2 Custom Built 18"-20" D (TBD), 30" W, 60" H Cabinets, Interior finished to homeowner's specification (TBD shiplap, beadboard, wallpaper or painted, etc.) With multiple interior hooks, location TBD, and one interior (adjustable height) shelf (aprox. 3-5 possible heights).

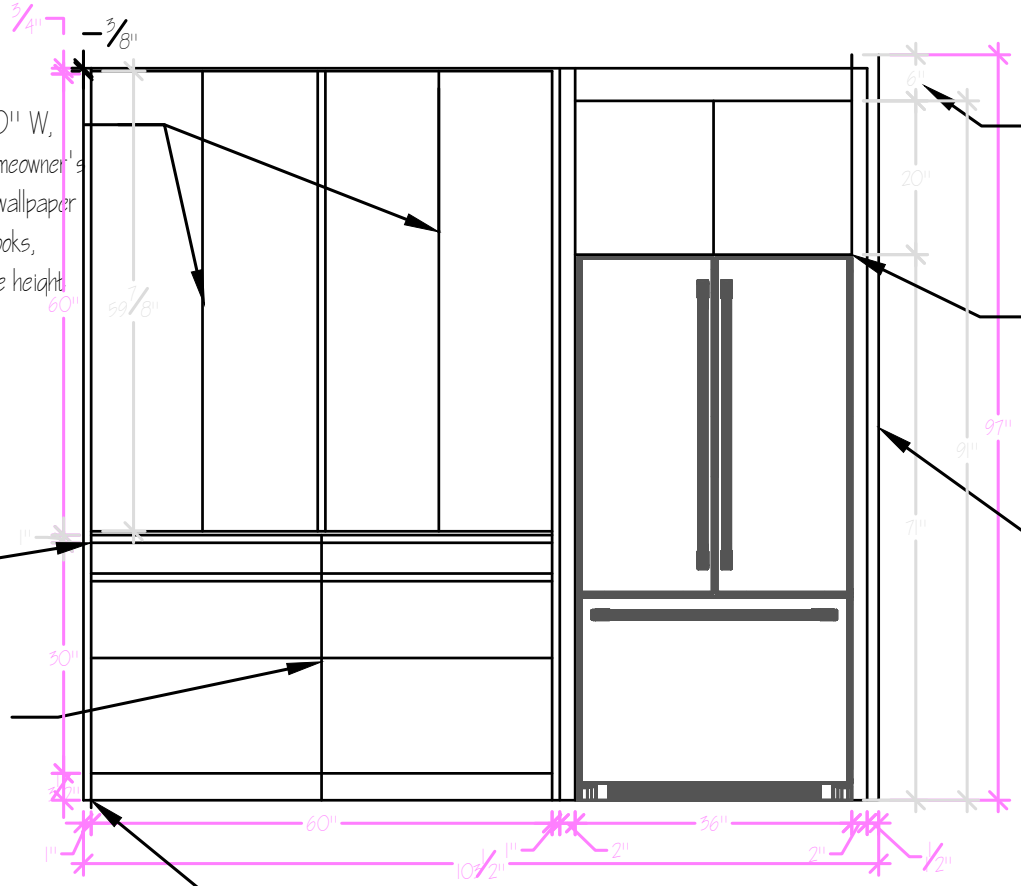
6" from top of cabinet to ceiling. wait to determine deco strip placement $\frac{3}{4}$" vs 2 $\frac{3}{8}$" side TBD this afternoon after I play around with mudroom side.

Deco strip can be placed here $\frac{3}{4}$" side) if homeowner deems 2" gap is too noticeable after refrigerator is installed.

NOTE counter top thickness: keep to minimum so that cabinet doors =60" and align with refrigerator height.

Reduce Toe kick to minimum (verify onsite with homeowner) to compensate for 60" door that aligns with fridge. IKEA SEKTION legs are adjustable from 3 $\frac{1}{2}$"-5 $\frac{1}{2}$" H. If possible adjust to 3 $\frac{1}{2}$"
